APPENDIX D
CORRESPONDENCE WITH SOUTHERN WATER

Proposal: Outline planning application for the erection of up to 140 dwellings including affordable housing, with public open space, landscaping, and vehicular access (all matters reserved except for access).

Site: 21/01822: - Land on The West Side of Cross Road, Deal, CT14 9LA.

Summary (Interpreted) Adit Plan From Operations Manual

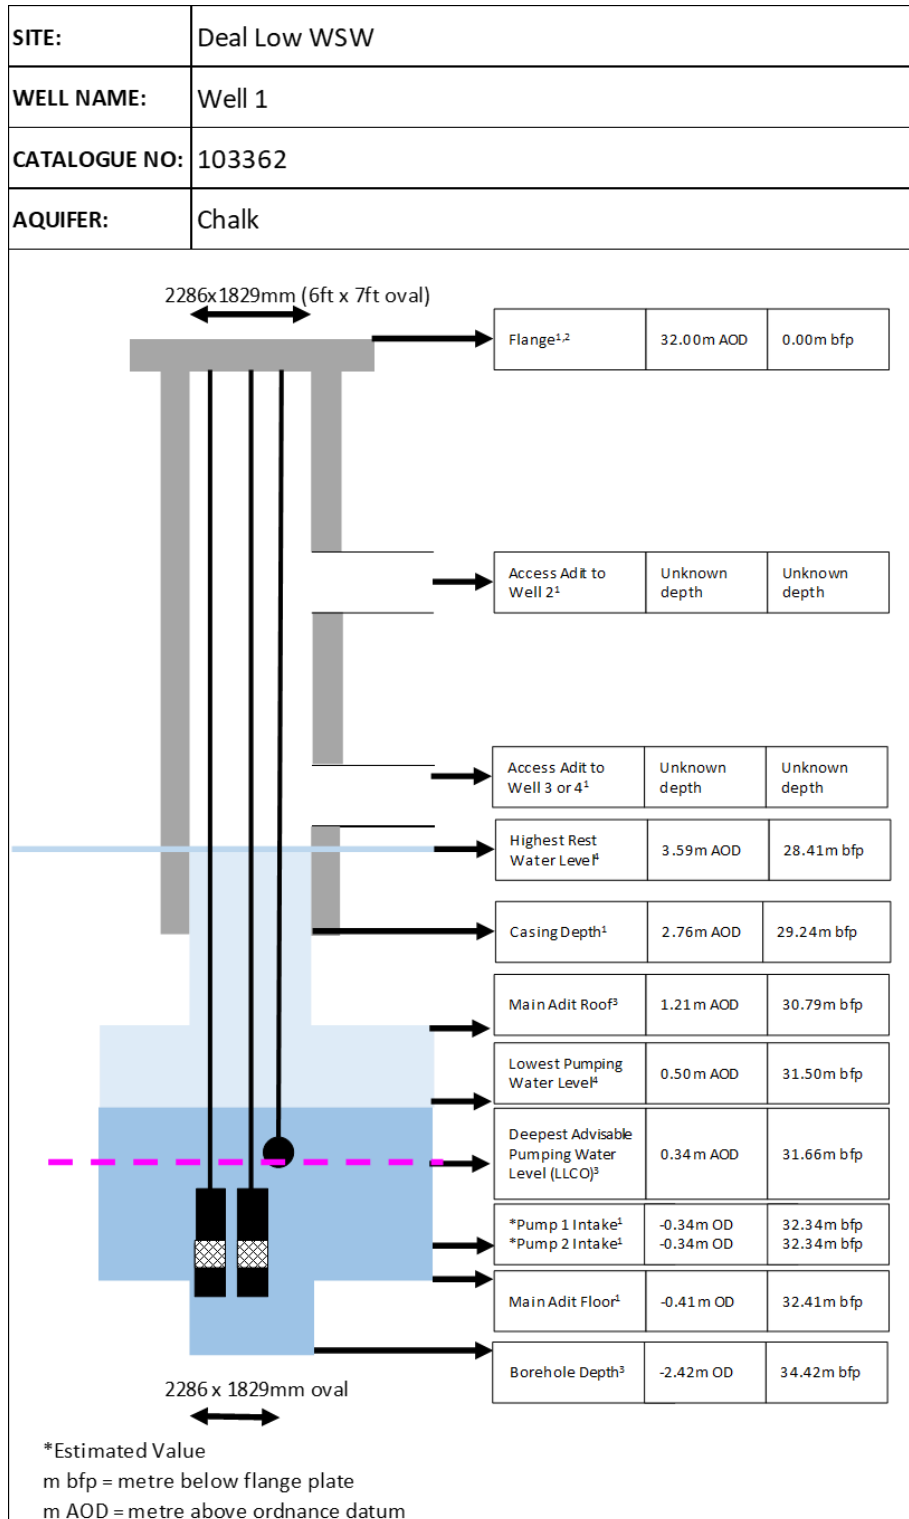
Please note although the annual and daily licensed rates are correct the hourly rate should be 409 m3 / hour. (90,000 gals/hour)
